Lower Colorado River Authority 3700 Lake Austin Blvd. Austin, TX 78703

RE: Burnet Quarry

Application #2024-5606 U2 (Update 2) Address: 3221 FM 3509, Burnet, TX 78611

We have reviewed the plans for the referenced permit application. The project proposes the use of Quarry Pits to meet the Performance Standards established by LCRA's Highland Lakes Watershed Ordinance. We have the following comments regarding the plans and application:

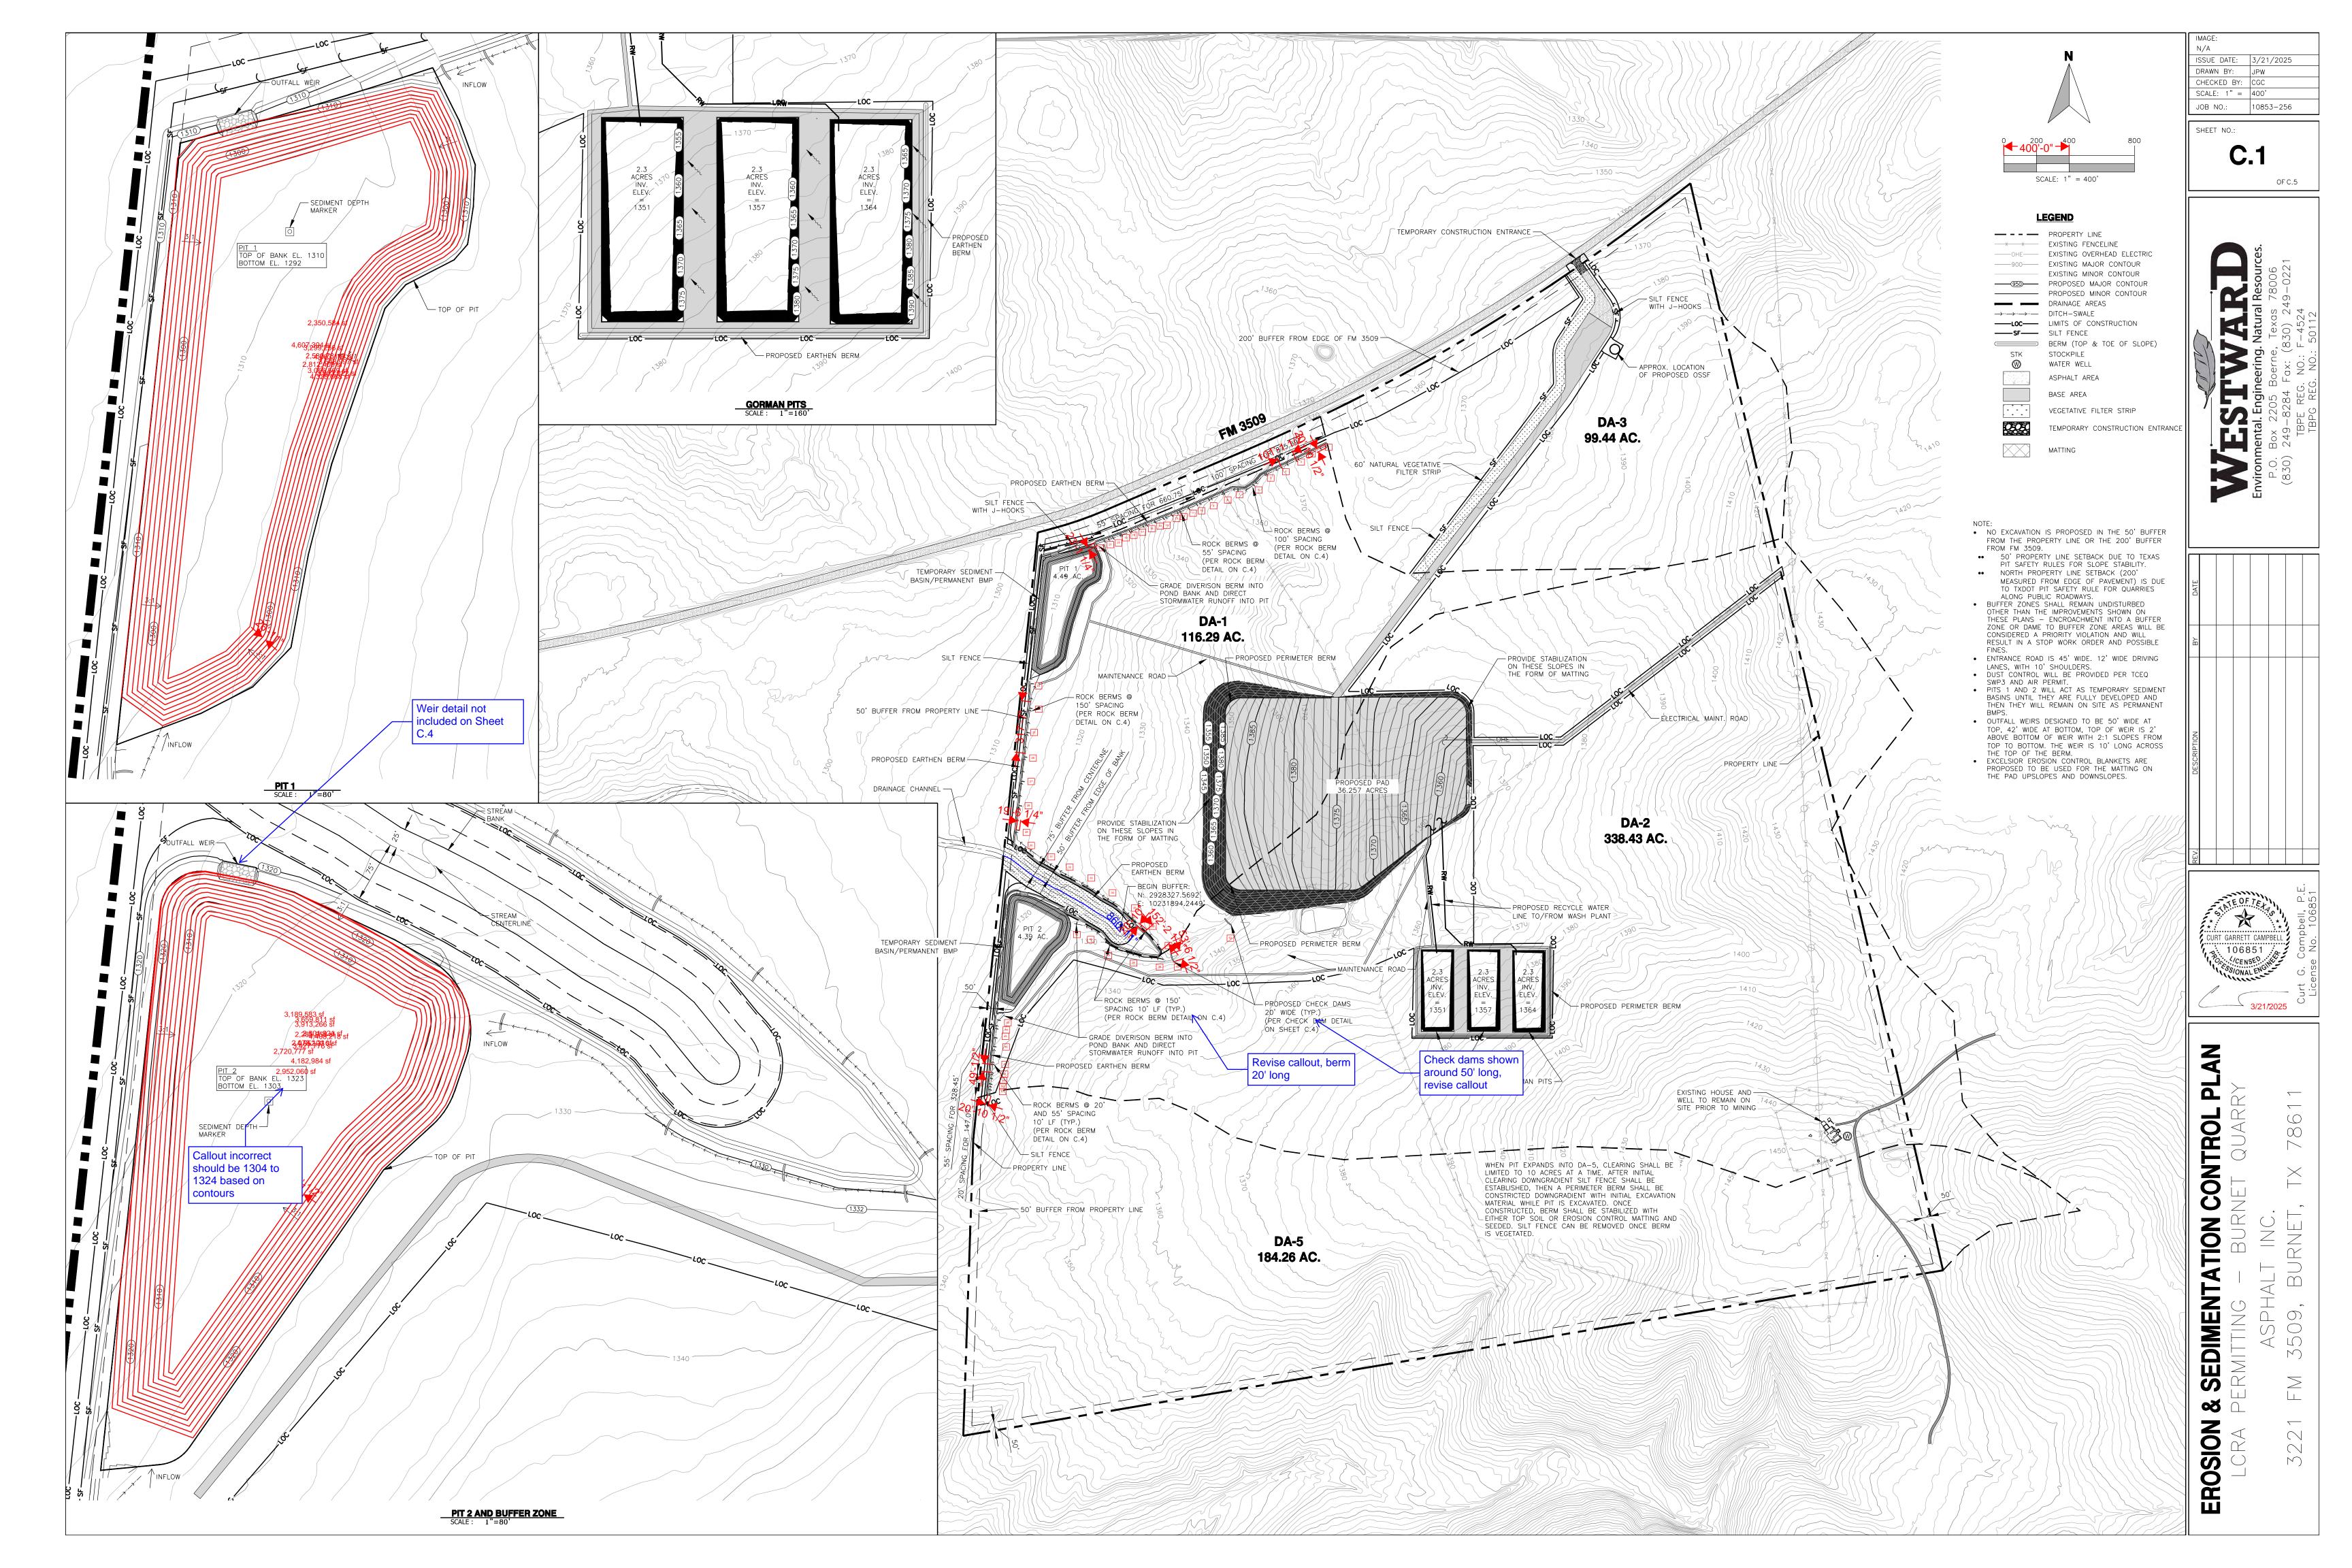
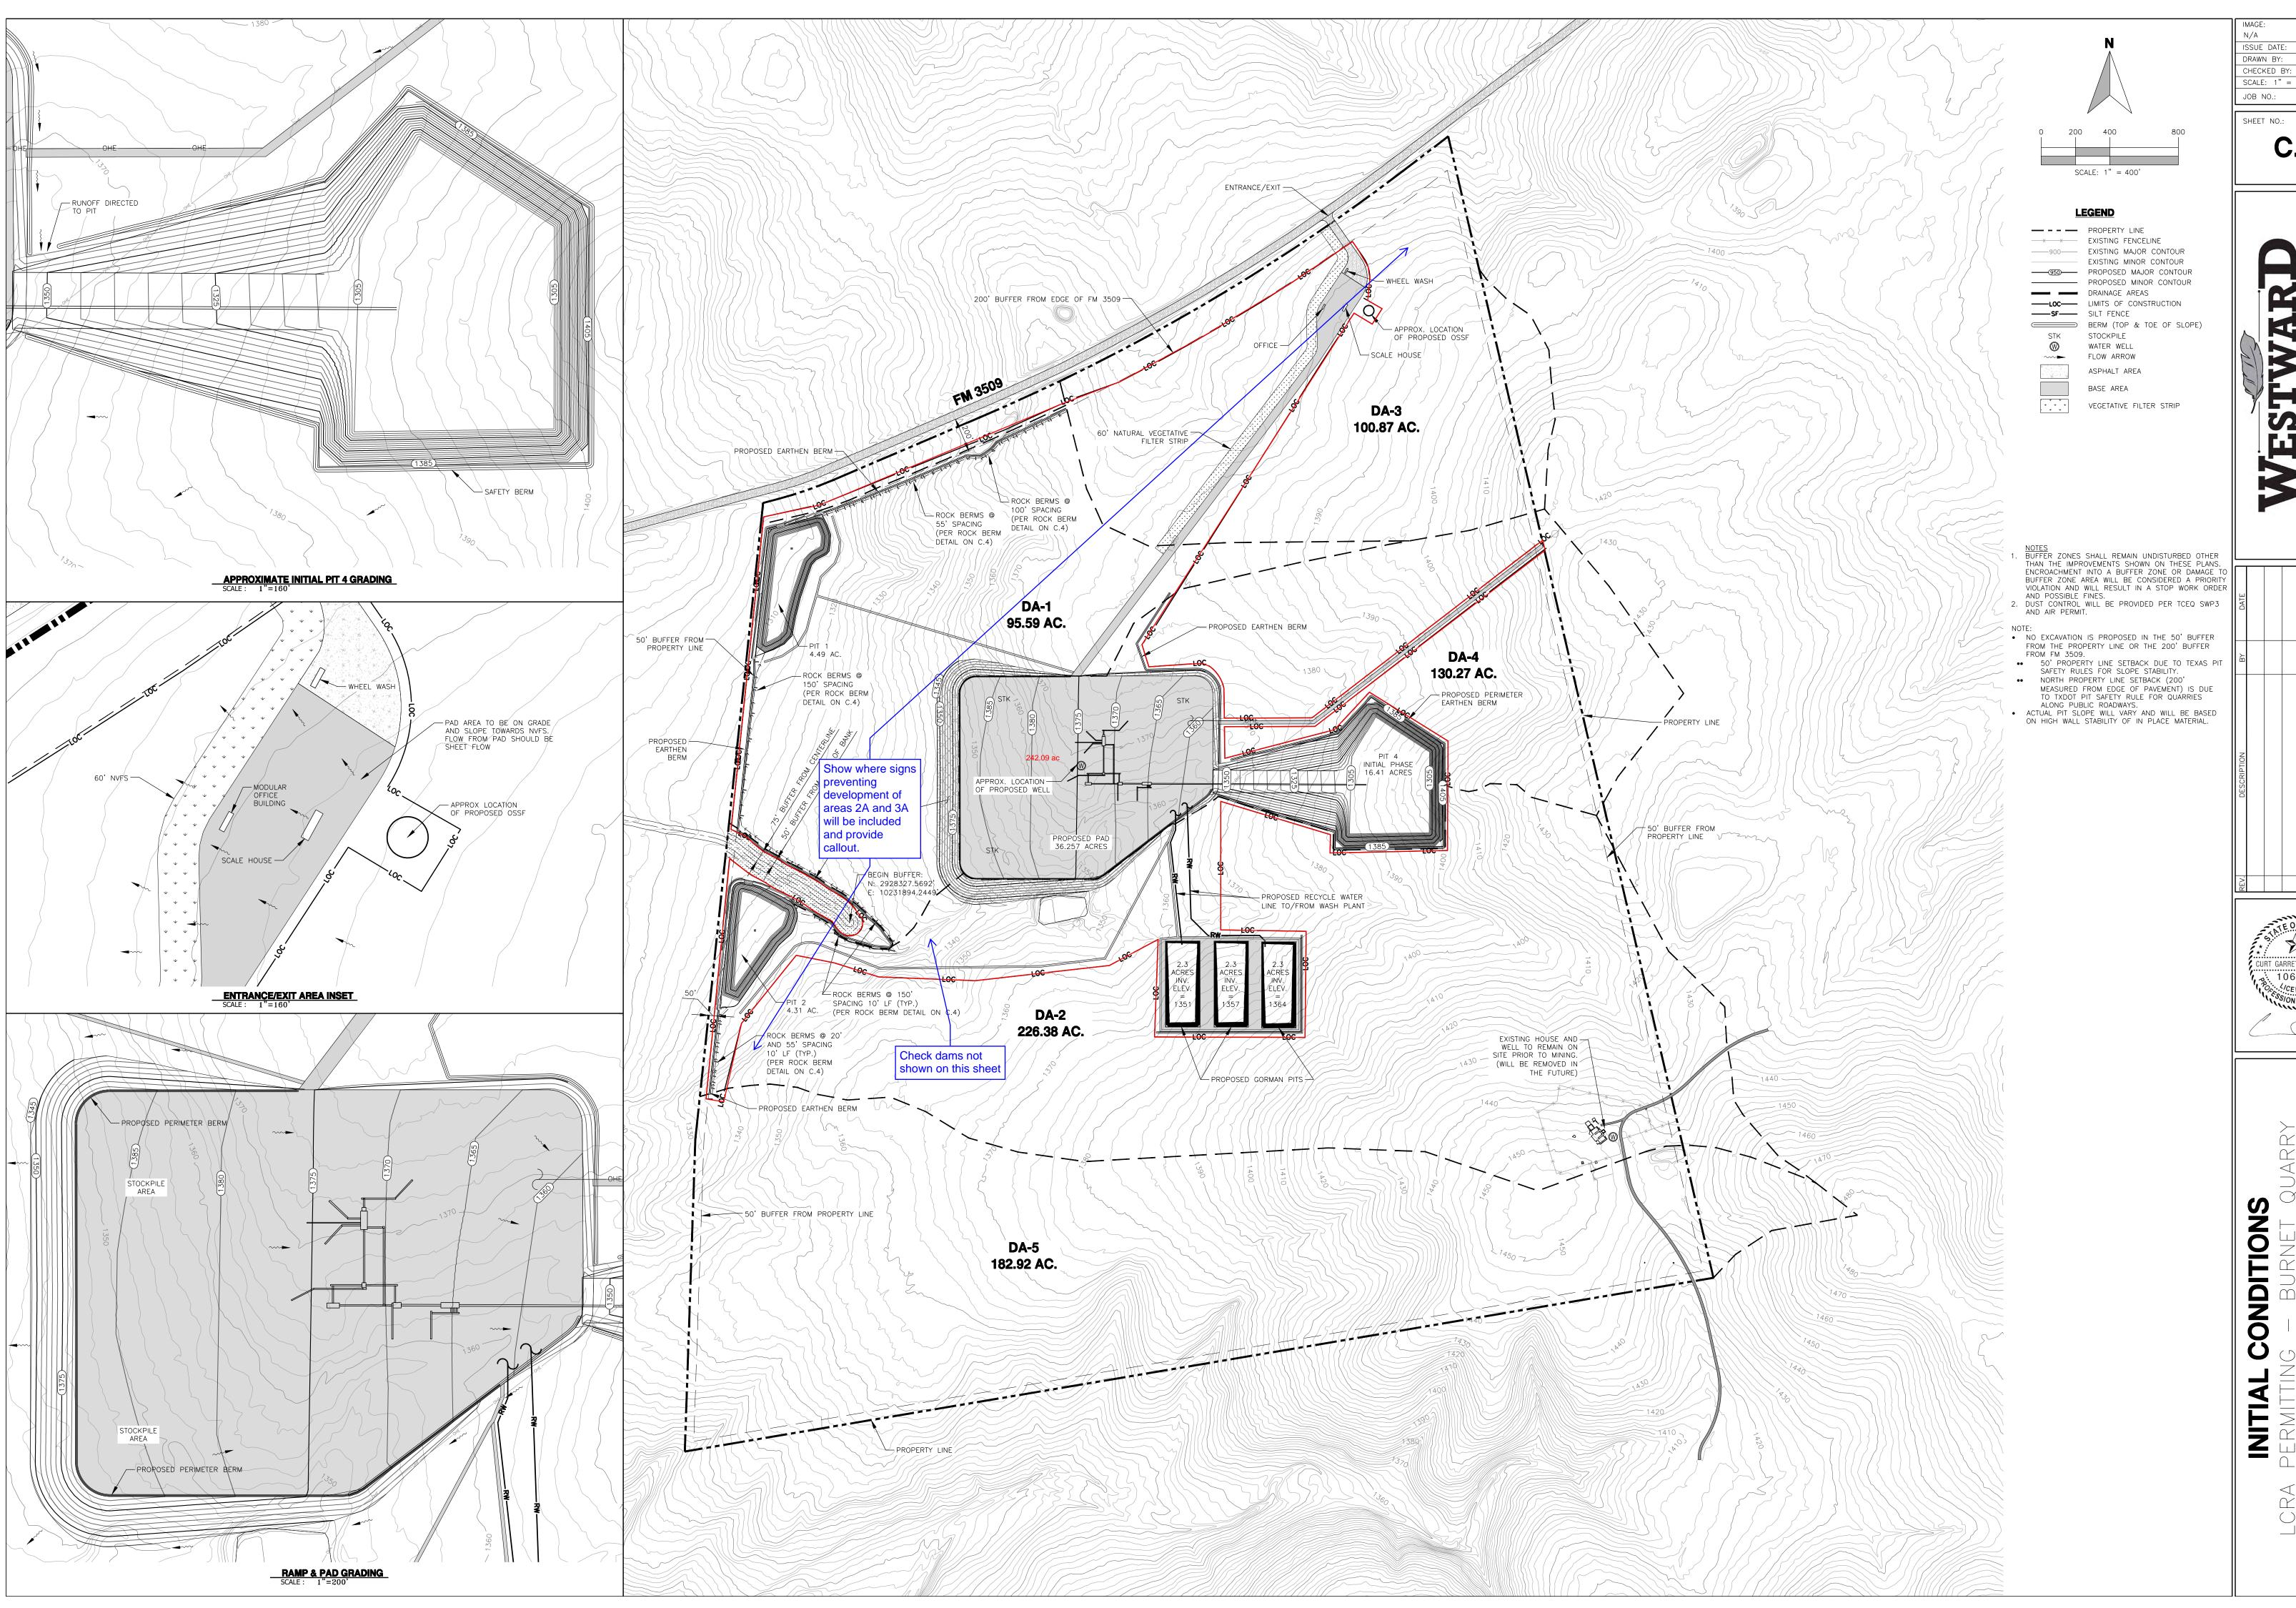
- 60. Please see marked up sheets to address any changes requested for this section or other sections.
 - Plan sheet C.1 Erosion & Sedimentation Control Plan
 - Plan sheet C.2. Initial Conditions
 - Plan sheet C.3 Final Conditions
 - Plan sheet C.4 Temporary General Notes
 - U1- Comment partially addressed. Please see plan sheet markups.
 - U2- Comment partially addressed. Please see plan sheet markups.
